STAFF REPORT: AUGUST 14, 2024 MEETING

APPLICATION NUMBER: HDC2024-00358

ADDRESS: 15035 ASHTON

SCOPE: ERECT ADDITION

Above: Staff’s July site visit photo, taken from the Ashton Road sidewalk, shows the wood fence that was erected in the rear yard, in line with the chain link fence.

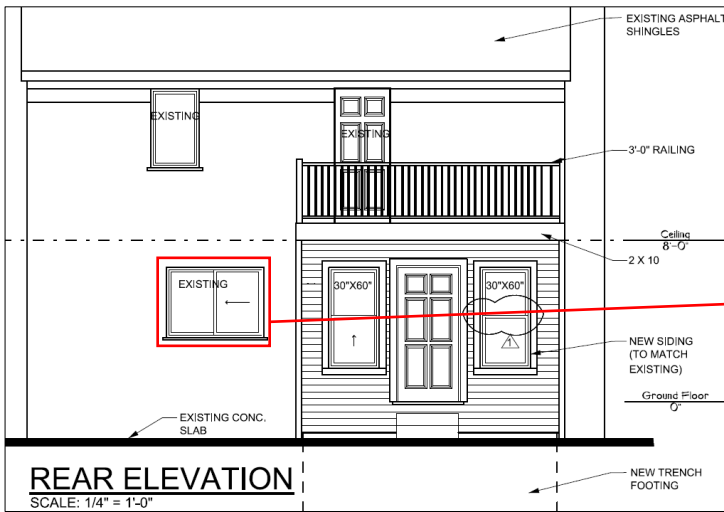
However, recent staff photos show a wood privacy fence, topped with wood lattice, has been erected. There is no record of HDC approval for the wood fencing. It is staff’s opinion that the location, wood material, and design fall within the Commission’s fence guidelines, as the lattice element has a square, rather than diamond-shaped pattern. However, the unpainted finish and outward facing support members do not meet the guidelines. Staff has contacted the applicant about this non-approved work.

Applicant drawing.

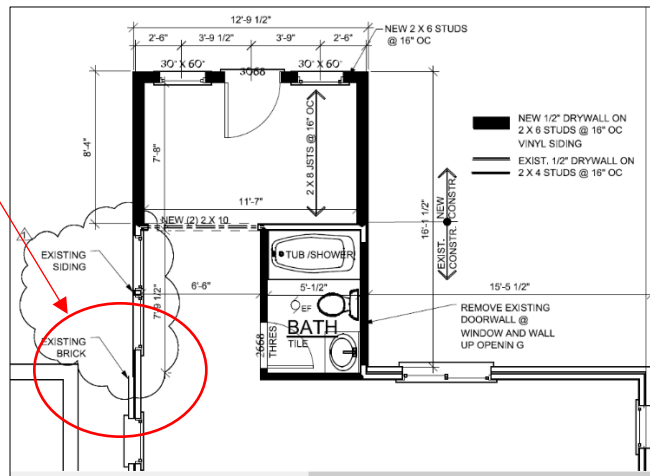
- The south/side elevation drawing shows solid walls and smaller double-hung windows, but the drawing states the existing full height windows will remain.
- The application says that vinyl siding “to match existing” will be installed. Vinyl siding is present on the front wall and has been in place since district designation. It is staff’s assumption the vinyl siding covers the original historic wood siding. The Commission consistently doesn’t approve the installation of vinyl siding, so there will be the opportunity to re-expose the wood siding when the vinyl deteriorates to the point of replacement.

- Wood or cementitious siding (smooth finish only) will be selected for the addition's walls; dimensions and profile will be specified. Paint color for walls and trim will be submitted for staff review.

- Aluminum-clad, one-over-one, double-hung wood windows will be selected. Manufacturer cut sheet(s) and cladding color will be submitted for staff review.

Applicant drawing of north wall.

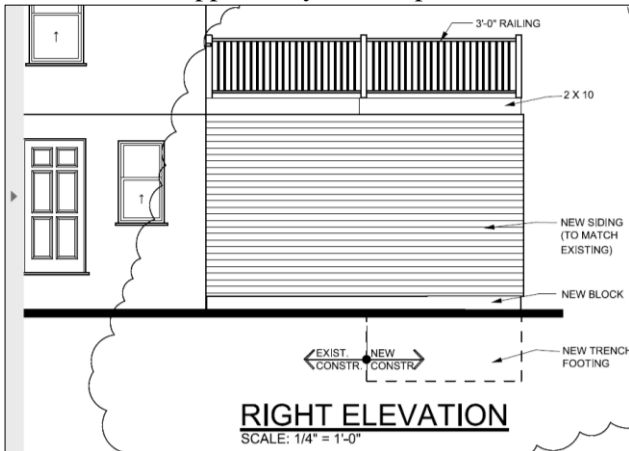
- The proposed north/side wall will become a solid wall, partially due to the interior design of a full bathroom. The other two walls will have multiple window openings, and the rear entry door will now face the backyard. The above aerial view shows how the interior/north wall is tucked in behind the house and is entirely hidden from public view.
